November 11, 2019

## Product Change Notice - Handrail kit prep slots added to SolidStep

Fig.1

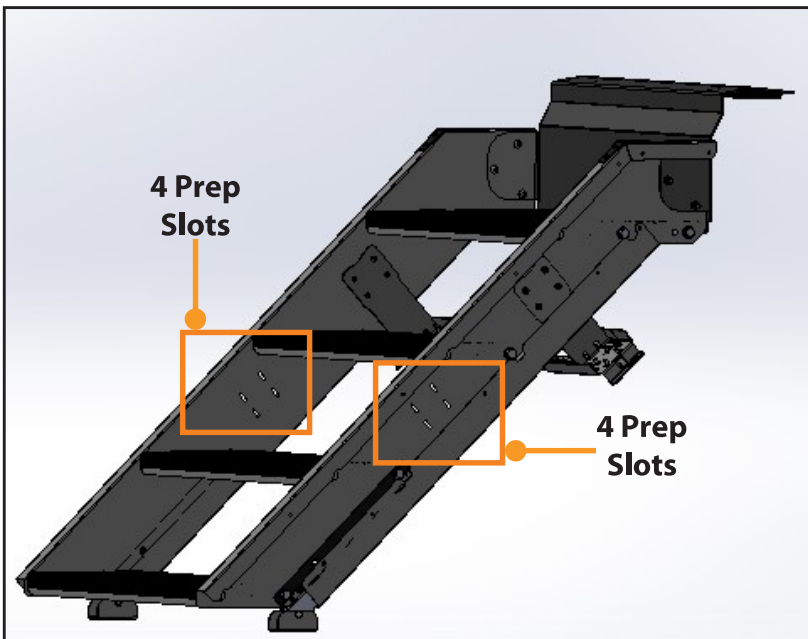
Four .200" slots will be added to the right and left side rails (Fig. 1). While the majority of handrails will be installed on the left side (Fig. 2) to accommodate right-hinge doors, holes were also added to right side rail to accommodate left-hinge doors.

Fig.2

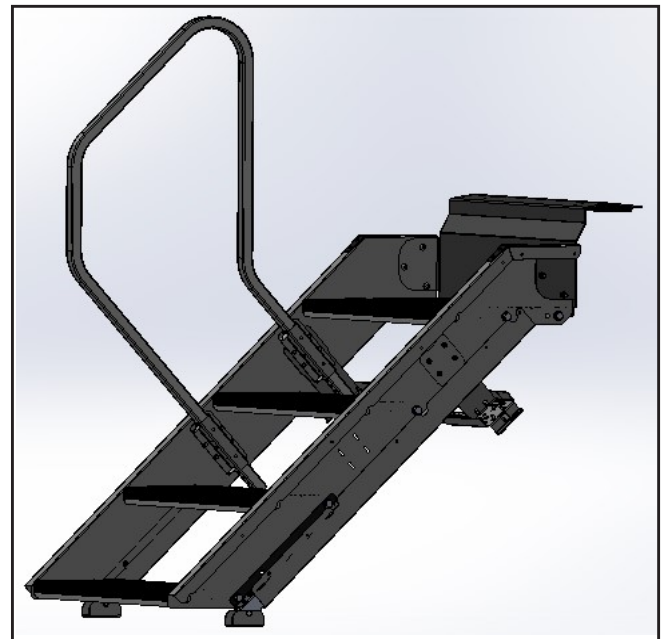
SolidStep with handrail installed on left side.
